DOCKETED	
Docket Number:	23-OPT-01
Project Title:	Fountain Wind Project
TN #:	254288
Document Title:	Jim Wiegand Comments - It appears people not even qualified,are providing biological input for Wind projects
Description:	N/A
Filer:	System
Organization:	Jim Wiegand
Submitter Role:	Public
Submission Date:	2/1/2024 12:11:21 PM
Docketed Date:	2/1/2024

It appears people not even qualified,are providing biological input for Wind projects

FOUNTAIN WIND PROJECT

FINAL ENVIRONMENTAL IMPACT REPORT - VOLUME 2

Hatchet Ridge Ten Years later

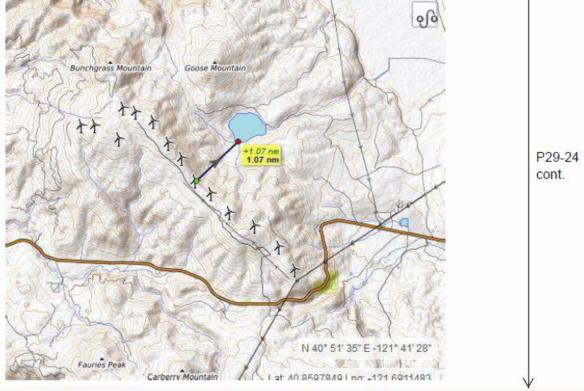
Now, 10 years after the Hatchet Ridge wind turbines started spinning, the Fountain Wind DEIR reported one occupied raptor nest, within 5 miles of these turbines with no credible explanations. Since 2010 bald eagles attempting to nest at Margaret lake, are very likely being killed off every year.

Abandoned Bald Eagle Nest No proof of occupancy ever given in EIR

No evidence was provided to show this nest was ever occupied after 2010 when the turbines became operational.

P29-24 The status of the Margaret Lake bald eagle nest is described in Response P29-10. While the comment speculates as much, there is no evidence that the Hatchet Ridge Wind Project caused the Margaret Lake bald eagle nest to fail in any year, let alone in every year since 2010. In addition, the comment also attempts to interpret monitoring data from Draft EIR Appendix C12, the *2018 Eagle Nest Status Survey Report*, as nest failures attributable to the Hatchet Ridge Wind Project. Although focused raptor surveys are no longer required for that project, project personnel are required to report eagle mortality, if and when identified. To date, bald eagle mortality has not been documented for the Hatchet Ridge Wind Project. Hence, the connection between bald eagle nest failures and this project has not been validated.

The comment takes issue with the change in eagle nest survey techniques from aerial helicopter surveys in 2017 (Draft EIR Appendix C10) to ground-based surveys in 2018 (Draft EIR Appendix C12), citing the change as a survey flaw. We note that the USFWS (2020) updated Eagle Survey protocol references ground-based and aerial-based surveys, which validates the multi-year survey conducted for the Project (e.g., see Comment A4-11). As the commenter notes, skilled raptor biologists can work effectively from the ground.

The commenter is correct that photograph of nest 308, a large unoccupied eagle nest, is the same in the 2017 and 2018 reports. The 2018 survey was done terrestrially and documented nest 308 as occupied and in use.
